Bedroom 1's bathroom · design review F-05 · accept the route (A) or a private bathroom (B)? · Taif / Palm House V8.1 · STUDY ONLY

OPTION A ADOPTED by the owner (2 Nov 2026): no private bathroom; the wet areas stay grouped in the two clusters; night lights along the route. 2 Nov 2026, after the stair flip (option B, F-b) · bedroom 1 is the north-east room over the maid wing, 15.75 m² on axes, 13.9 m² clear, one room without a bath · nothing in the design files changes until the owner decides · all sizes assumed

bedroom 1 · A · 1 m = 0.95 cm · north up · brown dotted = the ground floor below

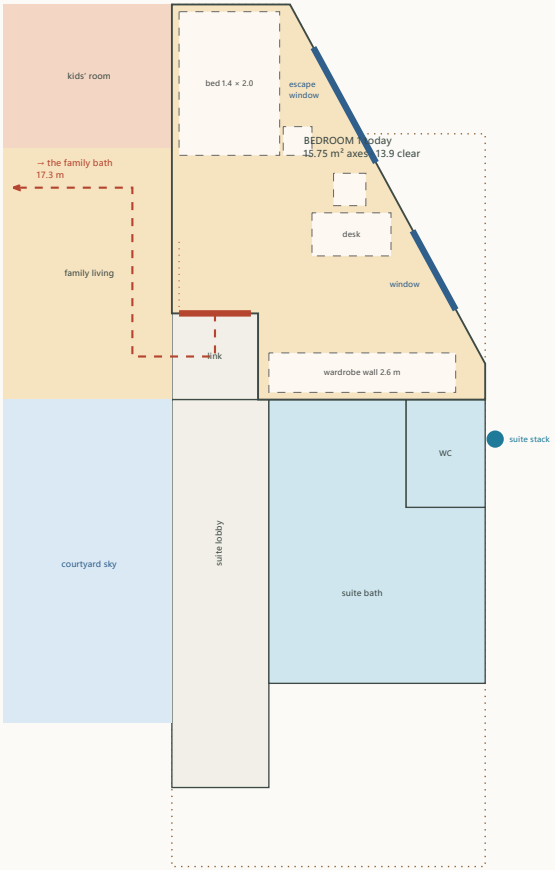
Option A · accept the route

- **The walk, measured after Part 1** (the stair flipped, the family bath enlarged northwards; its door stays at x 4.25, y 9.3–10.3): bedroom 1's door → the family link → the family living, behind the sofa → the gallery's north part, past the stair arrival → the gallery → the bath's door: **17.3 m** (the same as before the flip: the bath grew, its door did not move). Five spaces, two of them lived in (the living, the gallery).

- **Who shares the family bath:** bedroom 1 (17.3 m), bedroom 2 (2.7 m), the kids' room and the family living (a bedroom later); bedroom 3 and the suite have their own. Since F-b it has **two compartments** (a WC by the shaft and the shower + double basin), so two children at once.

- **Comfort:** a child or a guest in bedroom 1 crosses the **family living** at night and in the morning, in sight of whoever is there; 17 m is the longest bathroom walk in the house (the suite's is 0, bedroom 3's 2.7, bedroom 2's 2.7).

- **Cost:** nothing; the plumbing stays as it is.

bedroom 1 · B2 · 1 m = 0.95 cm · north up · brown dotted = the ground floor below

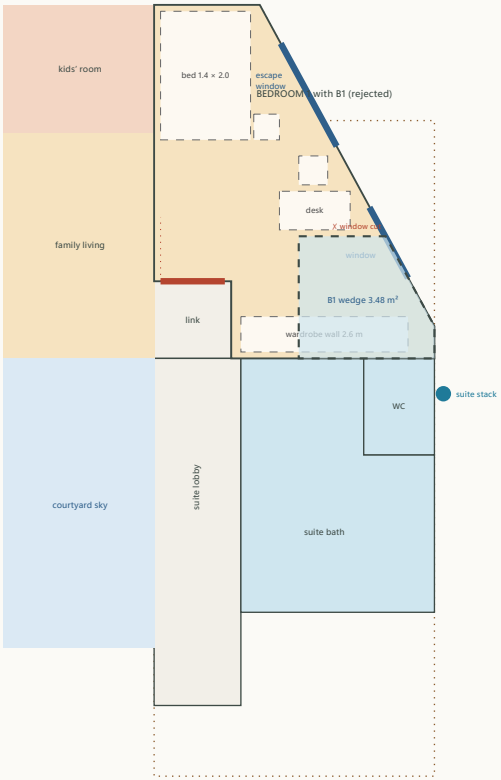
- **B2 (the best, drawn):** a bath along bedroom 1's **south wall**, x 10.6–13.311, y 5.0–6.5, its east end following the cut wall: **3.79 m² on axes, 2.49 × 1.3 clear less the slant ≈ 3.0 m²**: a walk-in shower 0.9 × 1.2 at the east end (its corner 0.02 m west of the cut wall), the WC in the middle facing north, the basin on the west wall, a **sliding 1.0 m door** from the room (no swing), a **small window on the cut wall** (y 5.35–5.85, sill +1.60, obscured). It is **next to the master suite's wet stack**: the pipes run 2.5 m east in the bath's own floor zone to the suite's stack outside the east wall (y 7.05), **over the GF maid room only** (the kitchen and its hood zone start at y 7.0; nothing over the master bedroom).

- **Bedroom 1 with B2: 11.96 m² on axes, ≈ 10.3 m² clear** (was 15.75 / 13.9): the bed 1.4 × 2.0 stays on the west wall with its bedside table, the desk and chair under the escape window, the wardrobe wall (2.6 m) becomes **two wardrobes, 1.3 m on the bath's wall and 0.9 m on the west wall** (2.2 m in all); the door's swing stays clear; the **escape window stays the room's** (the fire study unchanged); the second window (y 4.15–5.25) lights the desk. Still a full bedroom (a 1.4 bed, a desk, 2.2 m of wardrobe), no longer a two-bed room.

- **Drain:** the shower, the WC and the basin to one branch running east along the bath's south side to the **suite's stack** outside the east wall (y 7.05), 2.5 m; the branch crosses the room's south wall line at x 13.311 and turns south outside the wall for 0.6 m (or a second stack beside the suite's; the MEP engineer). **Over the GF maid room only**: not over the kitchen (y ≥ 7.0), its hood zone (the east wall y 10.2–11.2) or the master bedroom (x 8.95–13.311, y 11.9–19.25).

- **Structure (`studies/structure.typ`):** the maid wing's first-floor bay is a **solid 0.20 slab** spanning east–west 4.36 m to the cut wall; a 0.15 depressed zone cannot be cut from 0.20. Two ways, the engineer's choice: **(i)** cast the bay 0.35 thick under the bath with its top depressed 0.15 (as the suite bath, X10), or **(ii)** keep the slab and run the pipes **below** it in the maid room's ceiling void (the maid room gets a gypsum ceiling anyway; 3.1 m clear left) with a wall-hung WC and a shower tray raised ≈ 0.10. The bath's walls are light partitions on the slab (no beam; B6 at y 6.5 is the room's south wall beam, untouched).

- **Windows:** the bath's small window on the cut wall faces the lane side (obscured glass, a vent); the room keeps both its windows. **Ventilation:** the window plus an extract fan to the roof riser is not available here: an extract through the cut wall (a small louvre) or a duct in the ceiling void to the east wall.

- **Neighbours:** the maid room below hears the bath (pipes in a ceiling void: wrap them); the suite's WC closet shares the stack; the family link and the suite lobby are untouched; the family bath keeps serving bedroom 2, the kids' room and the living.

Recommendation: B2, if bedroom 1 is to be a guest room or an older child's room; otherwise A

- The route is the longest in the house and crosses the living: that is the real cost of A, and the only one. B2 answers it for ≈ 3 m² of the room and one more wet room; it is the only tidy position (B1 is a wedge that cuts a window, B3 takes the escape window). **Conditions for B2:** the engineer chooses the slab detail (i) or (ii); the MEP engineer the stack connection and the vent; the wardrobe split accepted.
- **If A:** keep the family bath as F-b (two compartments) and note in the house rules that bedroom 1's user has the family bath; nothing else to do.

bedroom 1 · B1 · 1 m = 0.95 cm · north up · brown dotted = the ground floor below

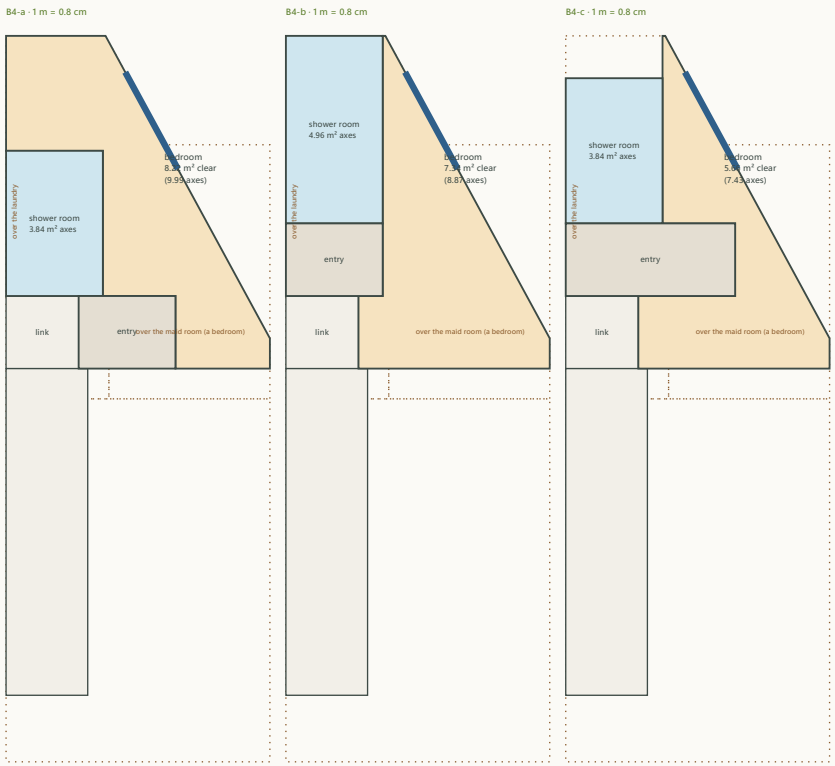
- **B1 (the south-east wedge, dashed on page 2):** x 11.2–13.311 on the cut wall, 3.48 m²: a wedge, its north wall cuts the second window (y 4.15–5.25) and leaves 0.8 m of the wardrobe wall: worse than B2 for the same plumbing. **B3 (the north-east corner):** the north-east corner (x 10.6–12.0, y 1.0–2.9) holds the room's **escape window** and the bed's head wall: a bath there moves the escape window and the bed; rejected without drawing.
